4/23/03	Revised 6'x4' Culvert Extension Per Change Order
DATE	REVISION
STATE OF HAWAII DEPARTMENT OF TRANSPORTATION HIGHWAYS DIVISION DRAINAGE PLAN - 1 KAMEHAMEHA HIGHWAY RESURFACING Waiahole Valley Road to Crouching Lion Inn Federal Aid Project No. NH-083-1(43)	
Scale: 1" = 10'	Date: August 1, 2000
SHEET No. C-27 OF 65 SHEETS

KAMEHAMEHA HIGHWAY RESURFACING
Waiahole Valley Road to Crouching Lion Inn
Federal Aid Project No. NH-083-1(43)

FED. ROAD DIST. NO.	STATE	FED. AID PROJ. NO.	FISCAL YEAR	SHEET NO.	TOTAL SHEETS
HAWAII	HAW.	NH-083-1(43)	2001	C.O.34S-1	121

DRAINAGE PLAN - 3

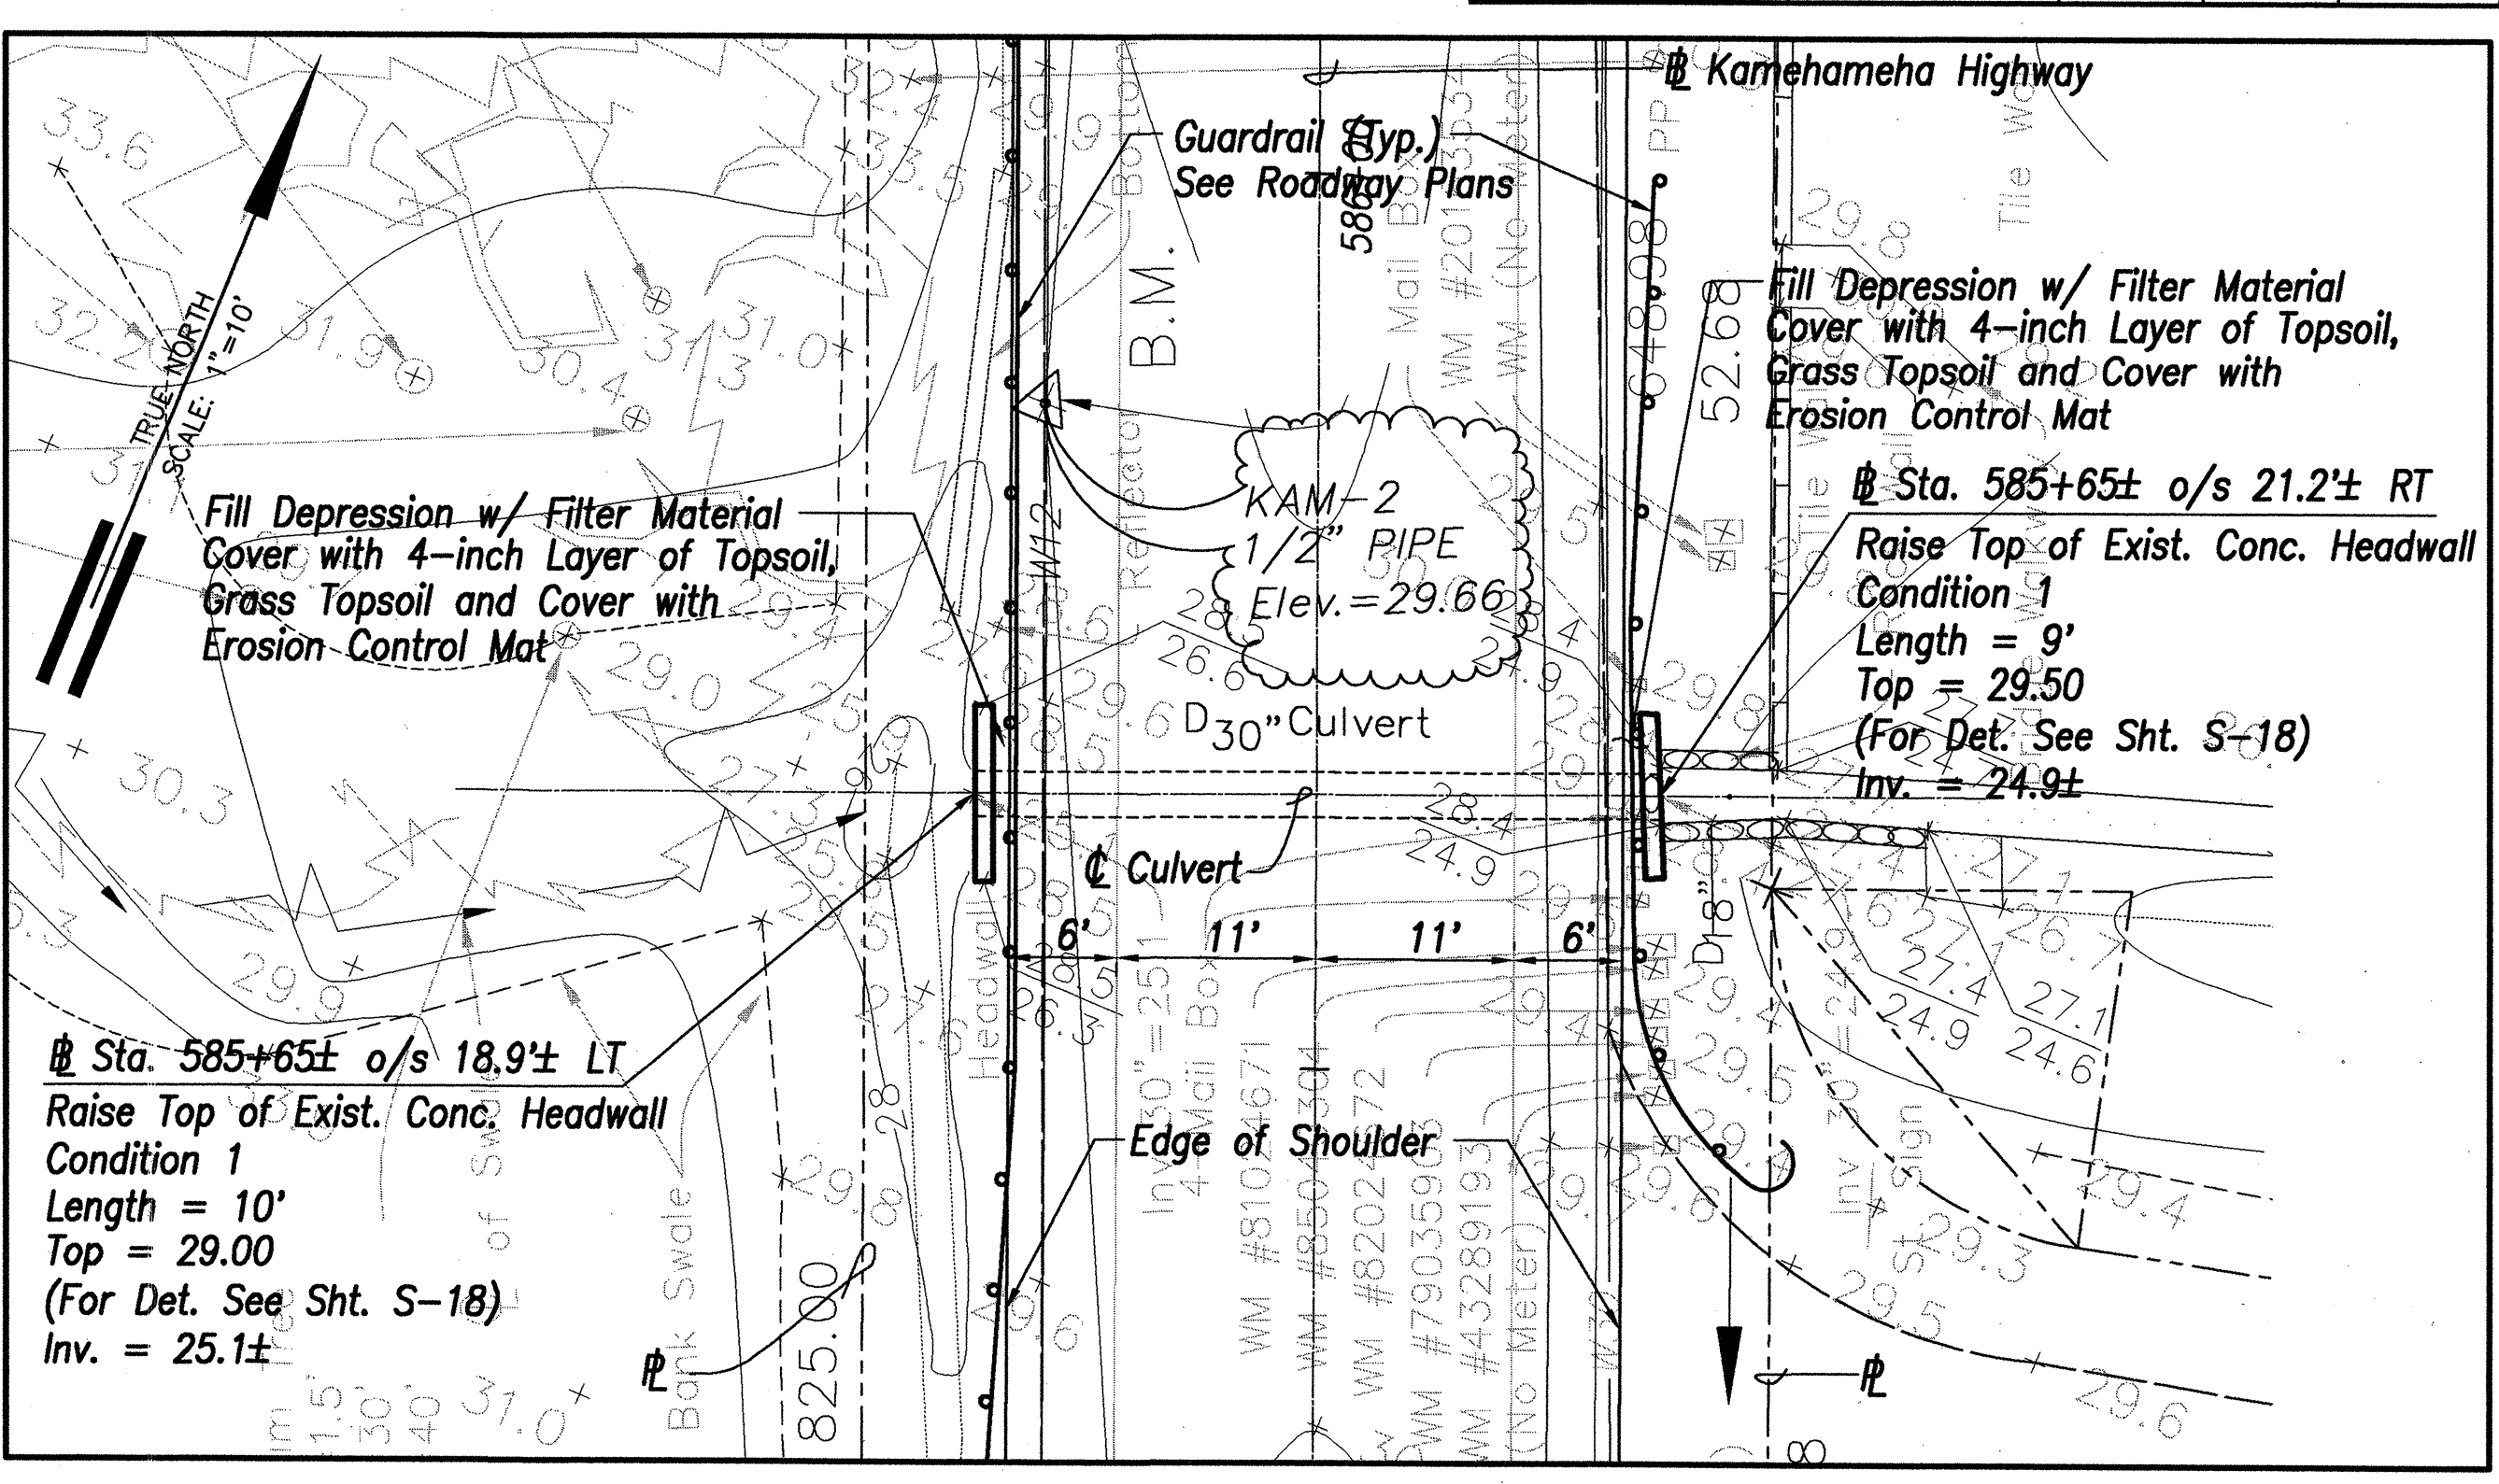
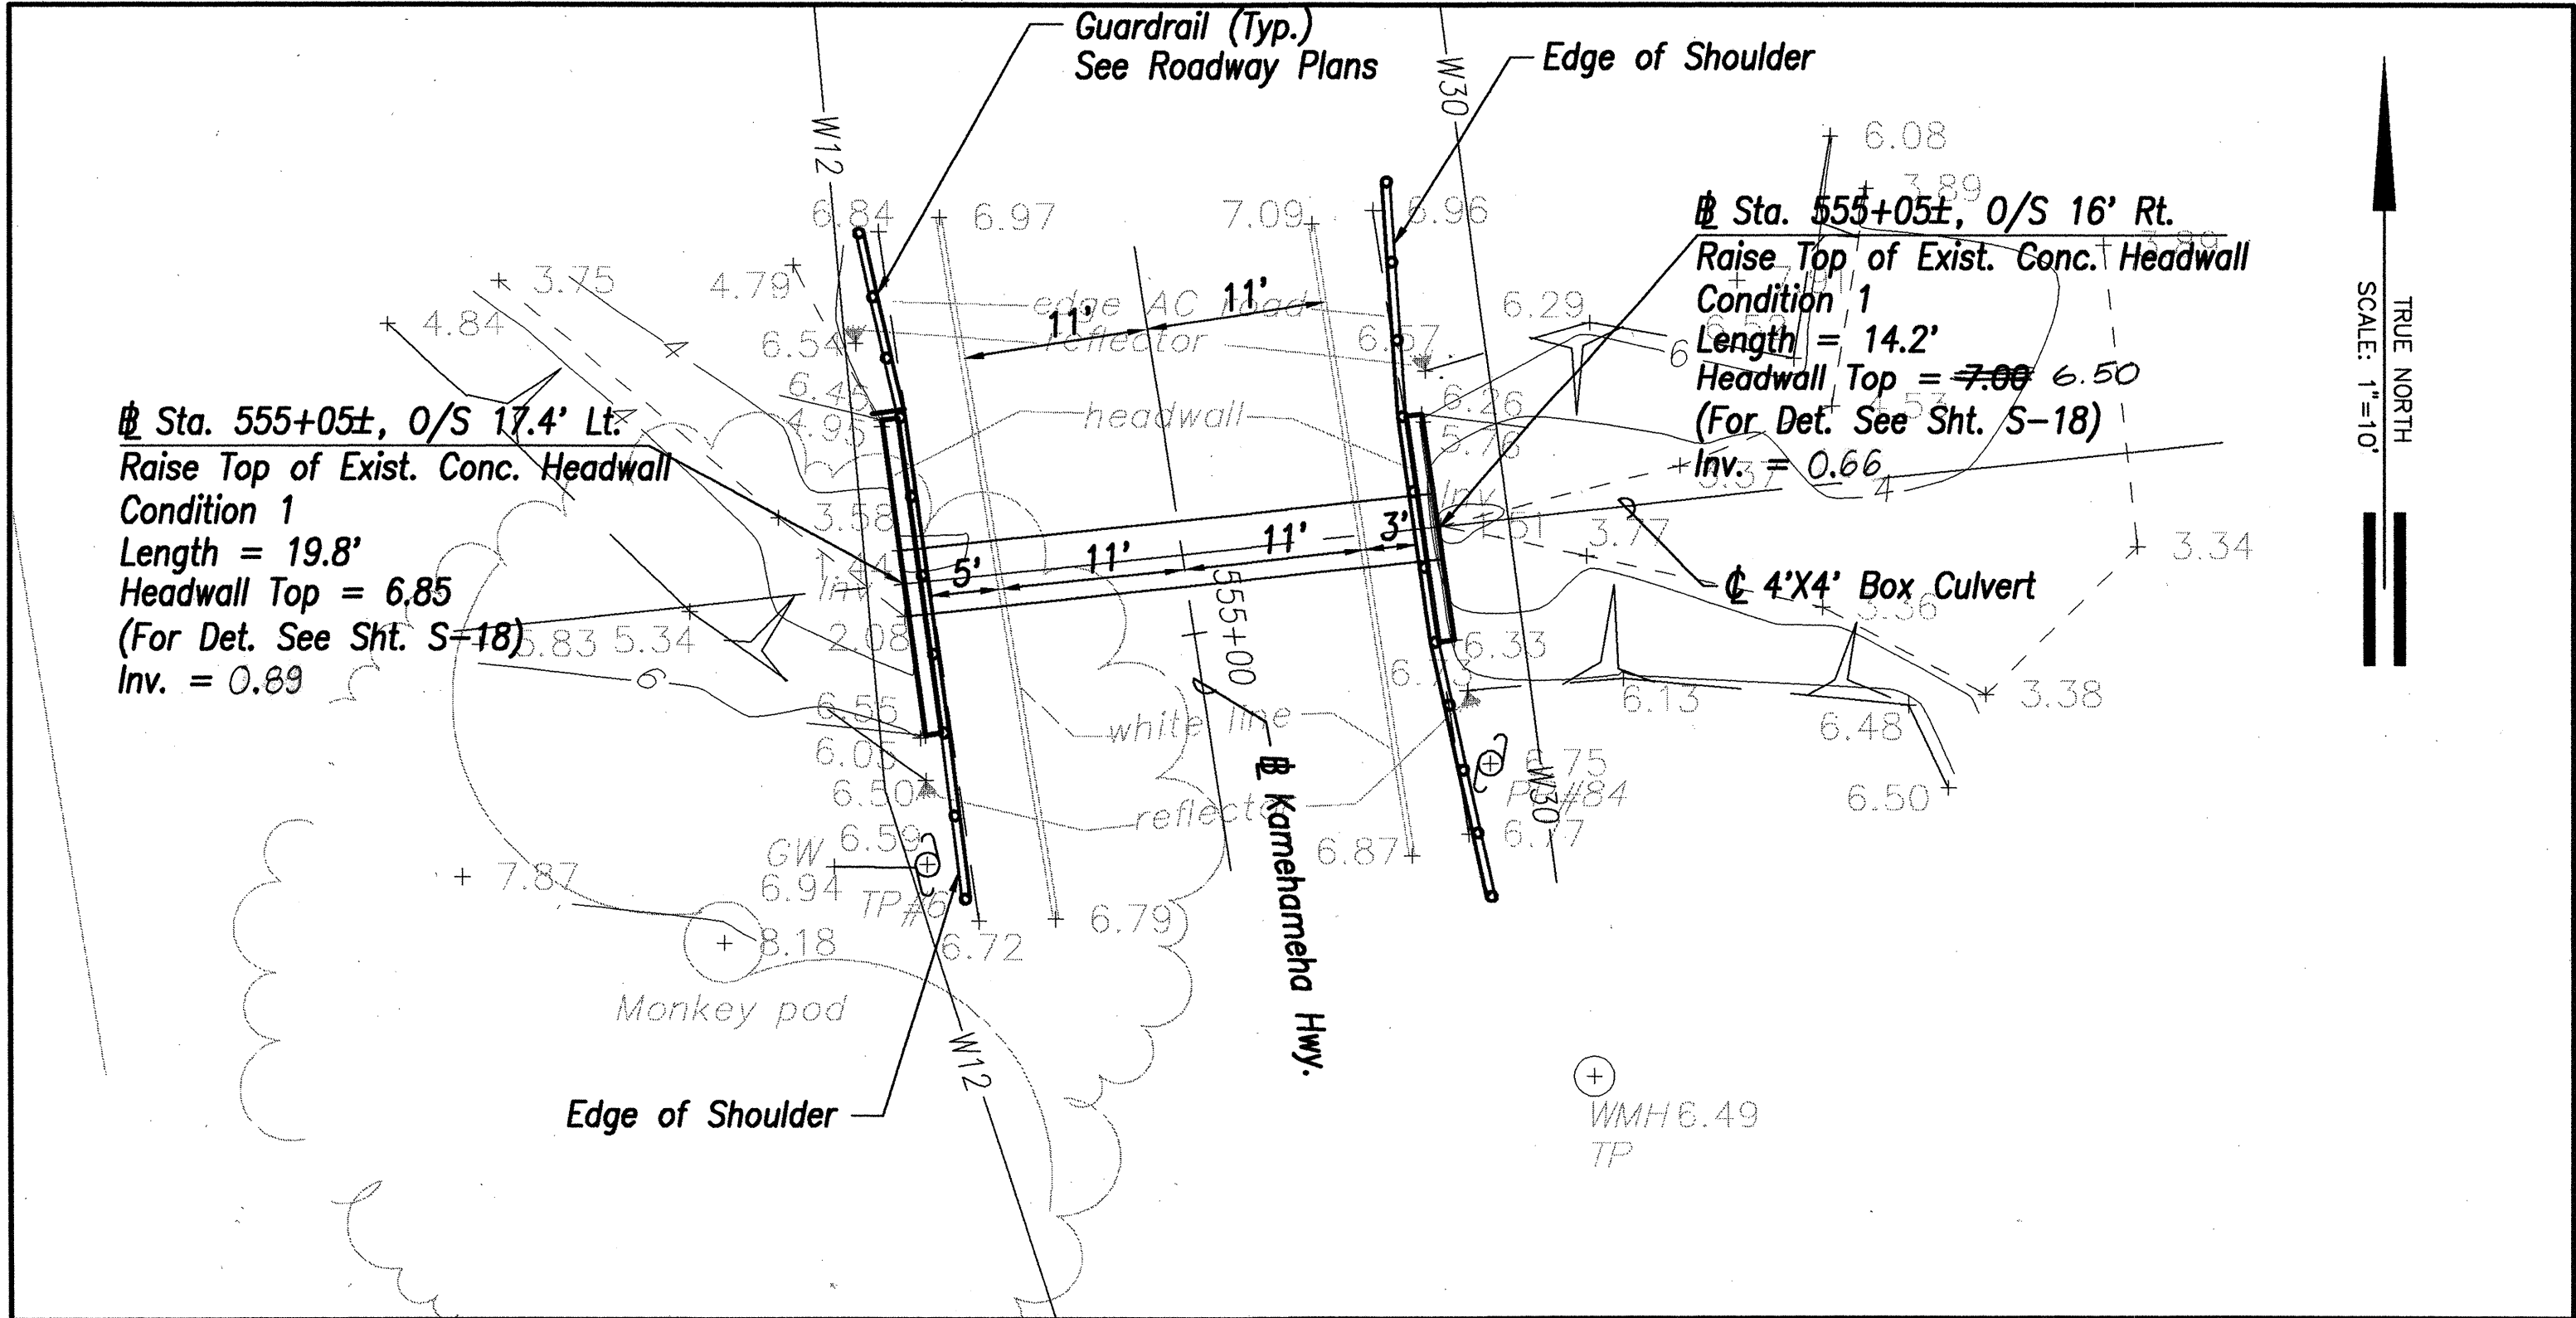
2/4/02	Revised Sta. 555+05 Culvert Inverts Per Addendum No. 2
DATE	REVISION
